SERVICE BULLETIN

Classification: EM13-007a	Reference: NTB14-003a	Date: December 17, 2014
------------------------------	--------------------------	----------------------------

2013-2014 SENTRA; ENGINE UPPER TORQUE ROD SERVICE INFORMATION

Figure 1

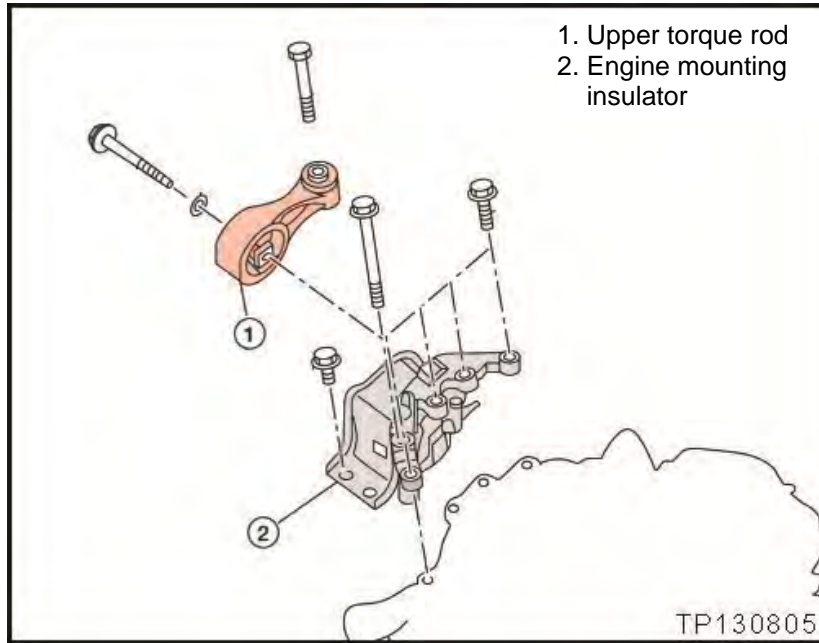
2013 Sentra: All models are equipped with an upper torque rod.

- These vehicles have an engine mounting insulator that requires an upper torque rod.

* **2014 Sentra:** S models built BEFORE 3N1AB7AP(*)EL 606447 and November 2, 2013 are equipped with an upper torque rod.

- These vehicles have an engine mounting insulator that requires an upper torque rod.

Figure 3

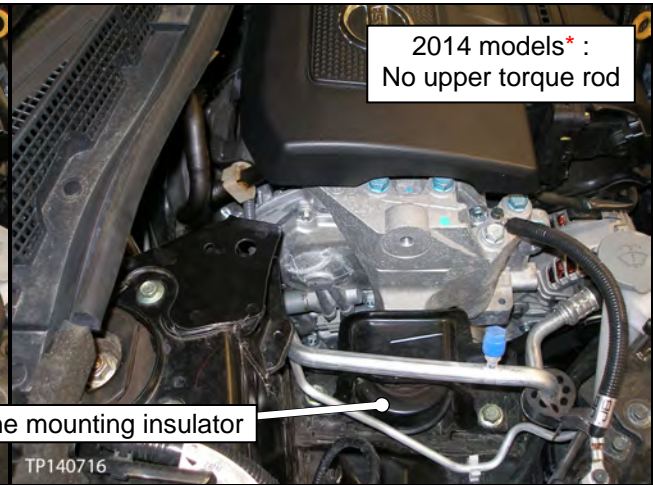
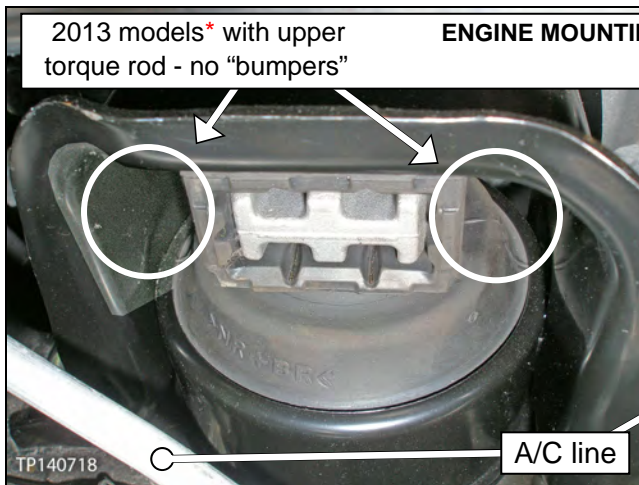
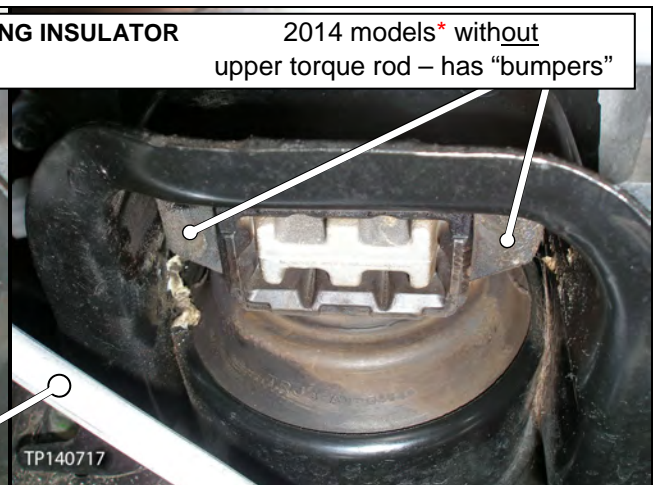
2014 Sentra: All SV, SL, and SR models **DO NOT HAVE** an upper torque rod. **DO NOT INSTALL an upper torque rod on these models for any reason.**

- These vehicles have a redesigned engine mounting insulator that does not require an upper torque rod.

2014 Sentra: S models built ON and AFTER 3N1AB7AP(*)EL 606447 and November 2, 2013 **DO NOT HAVE** an upper torque rod. **DO NOT INSTALL an upper torque rod on these models for any reason.**

- These vehicles have a redesigned engine mounting insulator that does not require an upper torque rod.
